Planning CAG SEMK - Public Consultation Feedback & SPD Amendments

Date: 13th October 2020

Proposed main changes to the SEMK SPD

Reserve Option - V11

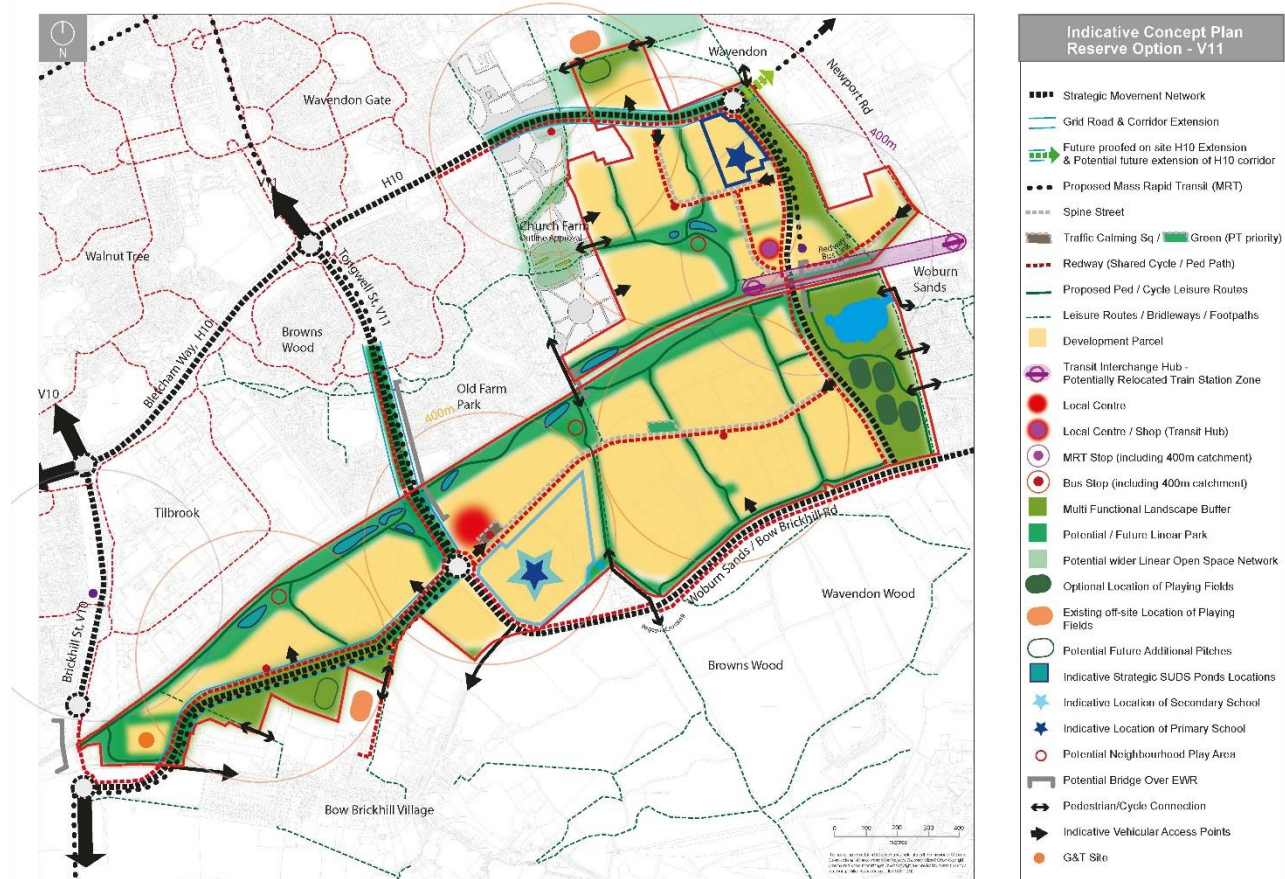
- This option will be 'active' if the V10 cannot be delivered on line or close to it and accommodating redways & MRT
- All other elements of the layout are the same

Changes to SPD

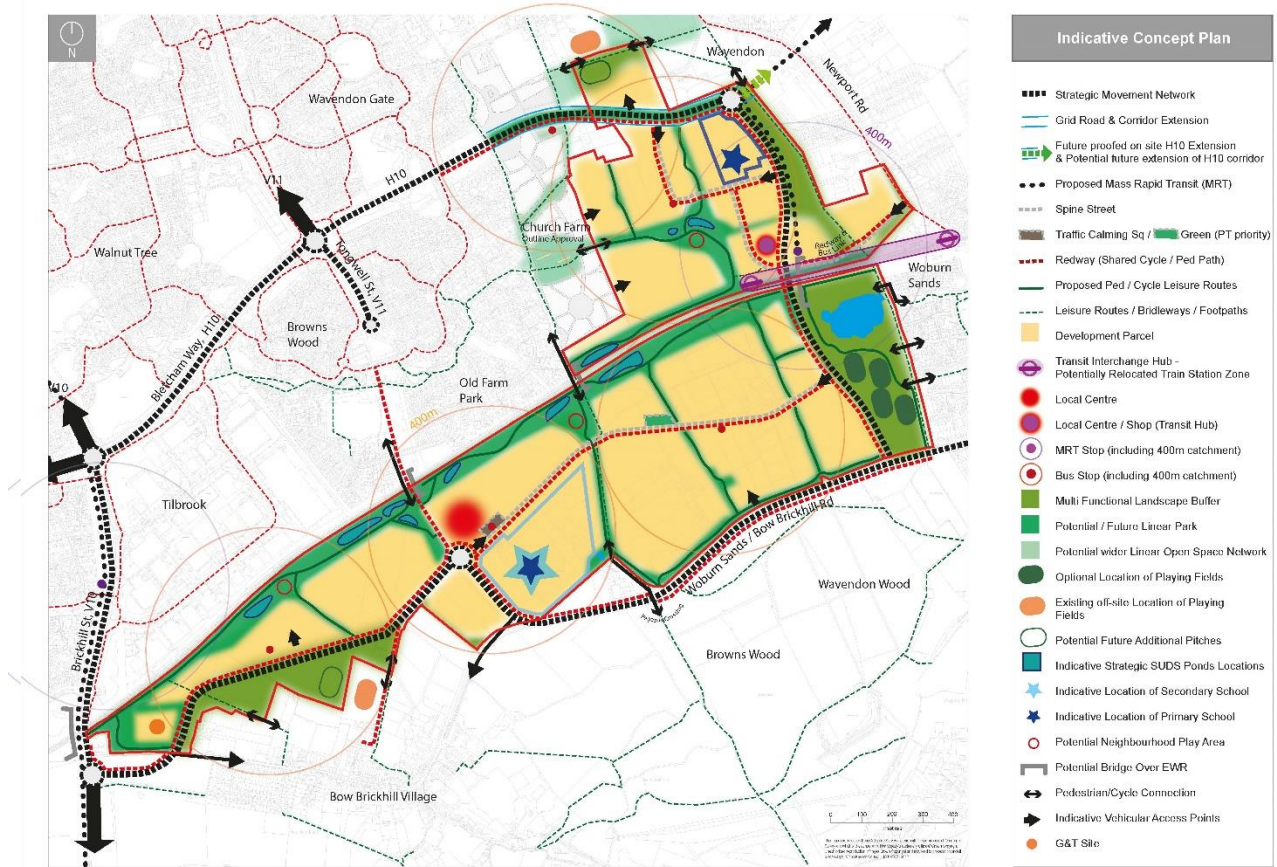
One main option

Relocated primary school

G&T site at far western end

Shown more context – Church Farm

Community Hub now called local centre

Changes to SPD

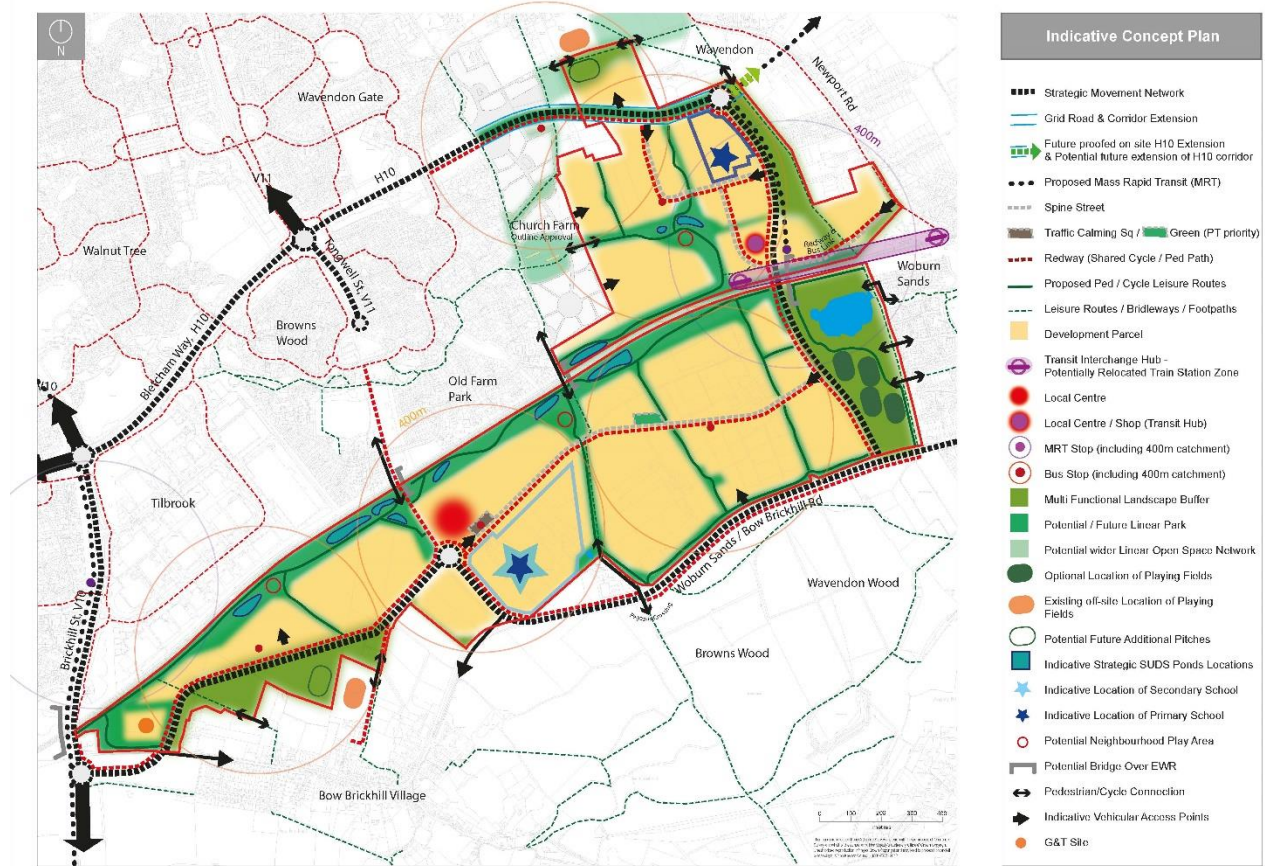
Stronger vision – landscape led approach

Focal open space provided adjacent to Spine Street

Extended interconnected open space network

Widened buffer to Wavendon

Playing fields preferred on Woburn Sands side

Changes to SPD

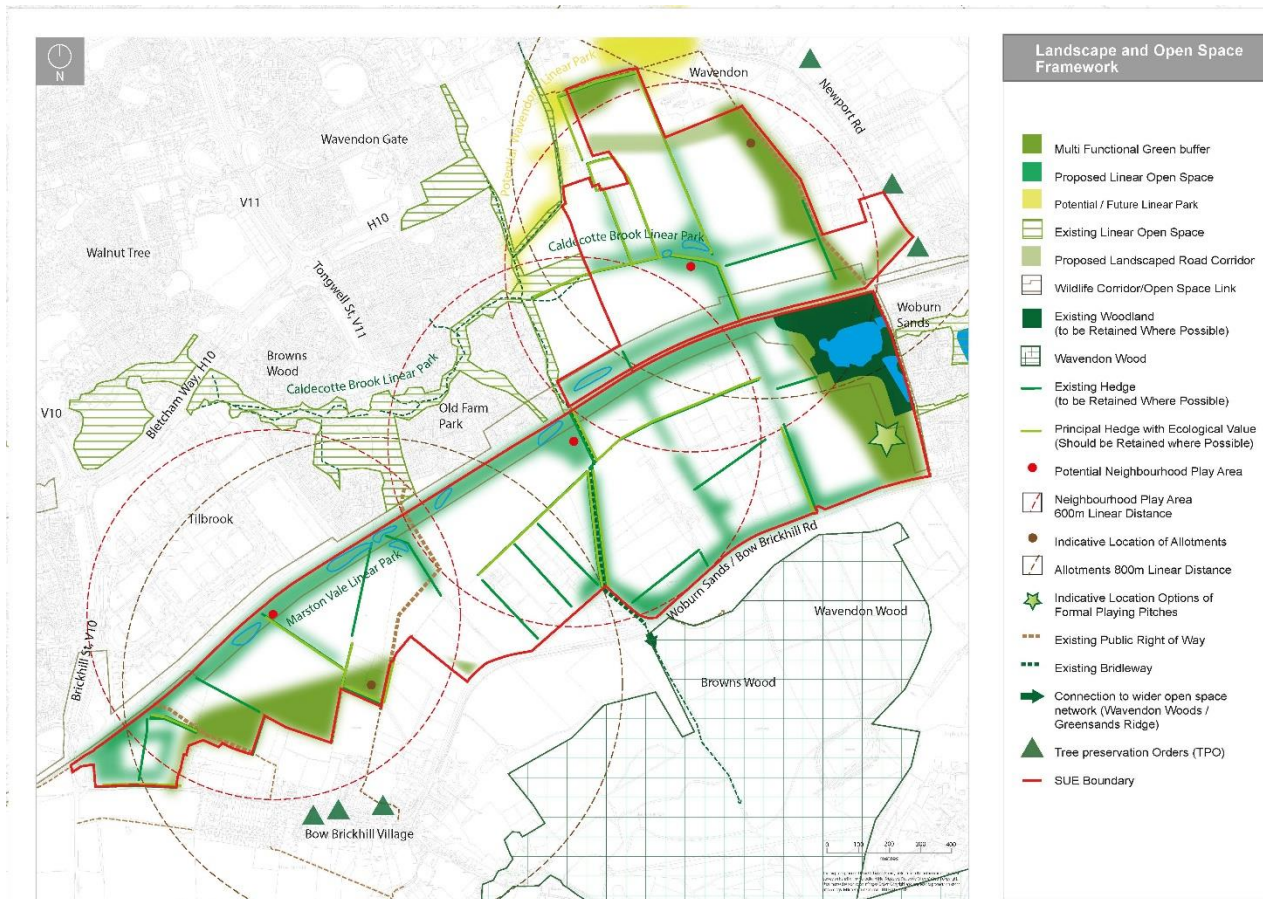
Open space network
added along Bow
Brickhill Road

Future linear park off
Caldecotte Brook Linear
Park, extending along
Phoebes Lane and
passing along southern
edge of Wavendon and
connection to potential
future growth areas to
the east of Newport
Road

Changes to SPD

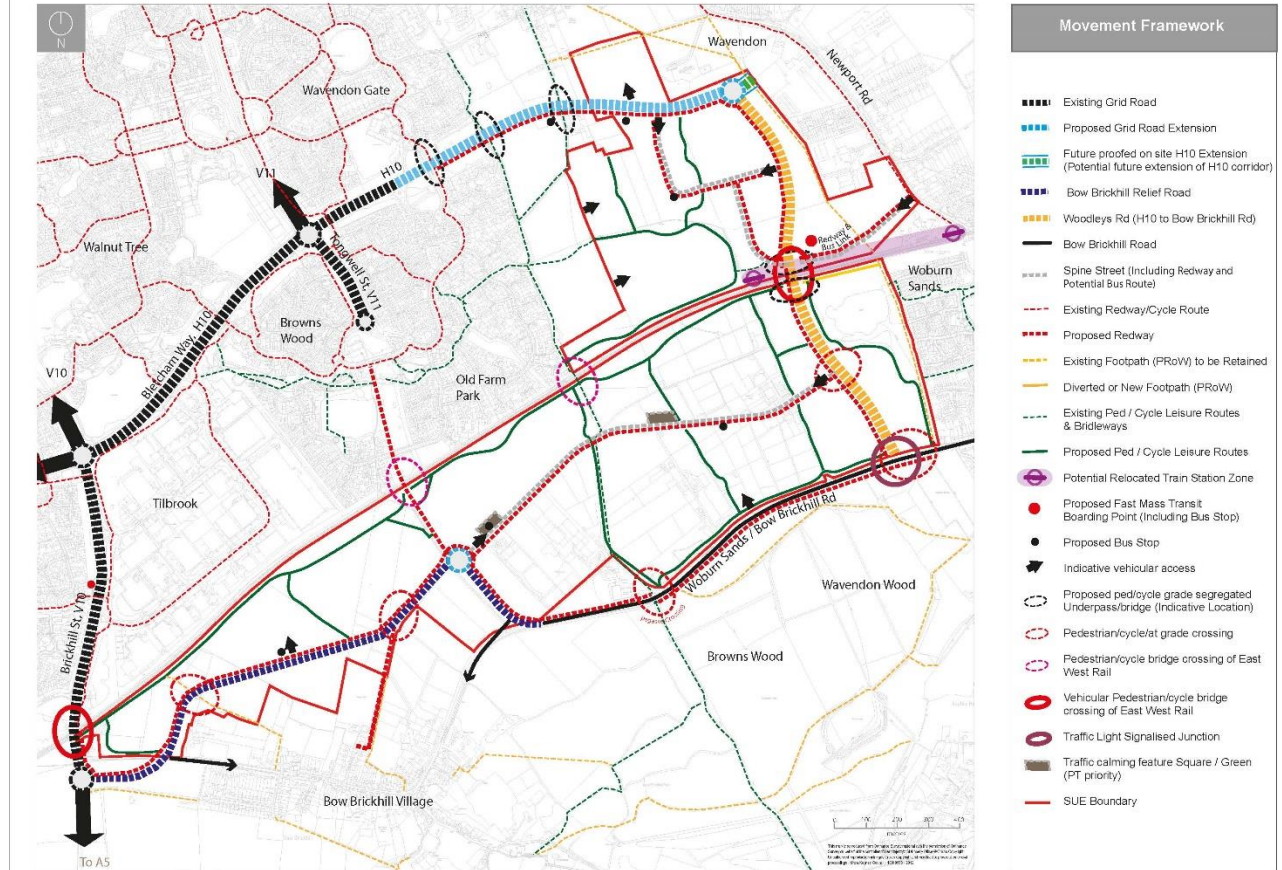
More clarity on nature of higher order movement network

Removed V11 future proofed corridor south of railway line but retain open space network

Development Framework Plan

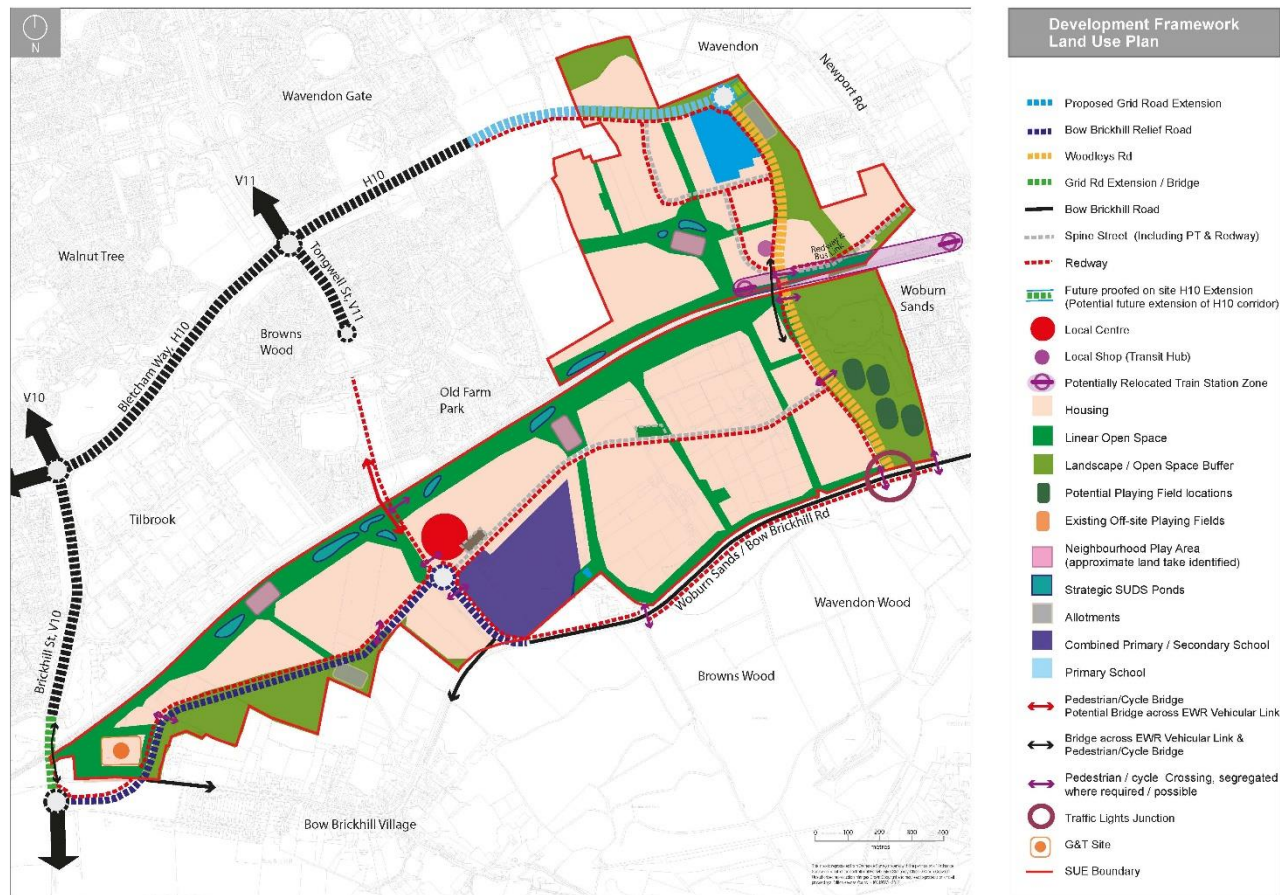
Character areas largely remains the same
